REGIONAL MUNICIPALITY OF OTTAWA-CARLETON  
MUNICIPALITÉ RÉGIONALE D'OTTAWA-CARLETON

SUBJECT/OBJET **MODIFICATIONS TO THE INTERSECTION OF BANK STREET AND CAHILL DRIVE - PUBLIC HEARING**

SUBJECT/OBJET         **MODIFICATIONS TO THE INTERSECTION OF BANK  
 STREET AND CAHILL DRIVE - ADDENDUM REPORT**

**Annex A**  
**Proposed Modifications**  
**Bank Street and Cahill Drive**

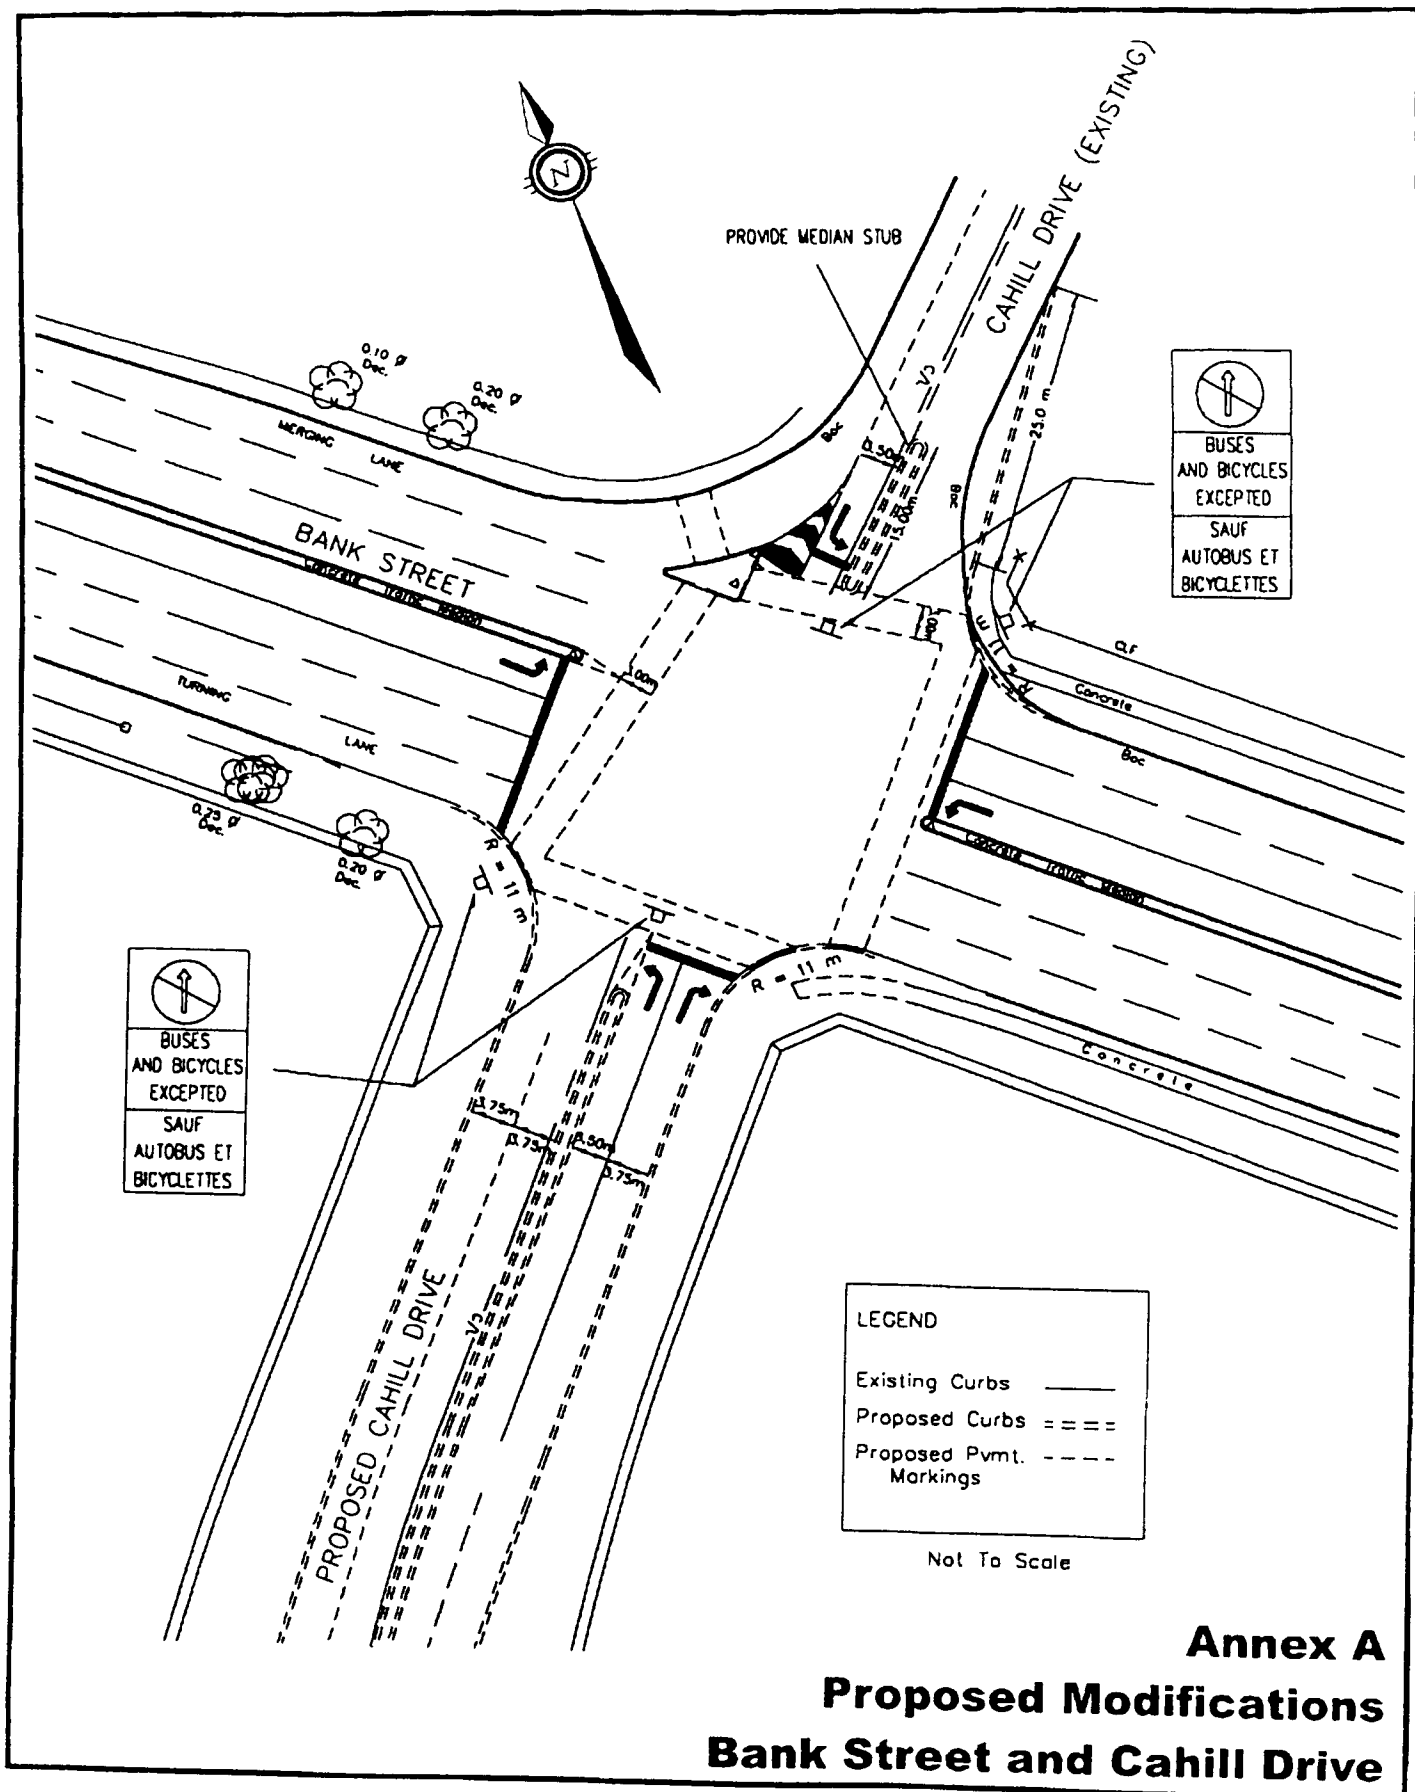
**That the Transportation Committee recommend Council approve the revised design modifications to the intersection of Bank Street and Cahill Drive which incorporates the removal of the proposed channelizing island situated in the north-west quadrant and the provision of reduced corner radii in the north-west and south-west quadrants as illustrated in Annex A.**

As indicated in the recommendation of this addendum report, the proposed channelizing island will be removed from the north-west quadrant of the intersection and replaced with a standard corner with a reduced radius. A channelizing island was proposed in the original intersection design to maintain existing pedestrian crossing distances across Bank Street and to safely accommodate moderate usage from large, right-turning trucks (tractor semi-trailers).

In addition to the provision of a reduced corner radius in the north-west quadrant of the intersection, current pedestrian crossing exposure can be reduced with a reduction in radii of the proposed south-west corner and the existing south-east corner. The resulting reduced crossing distances will enhance the pedestrians' level of comfort when using this intersection.
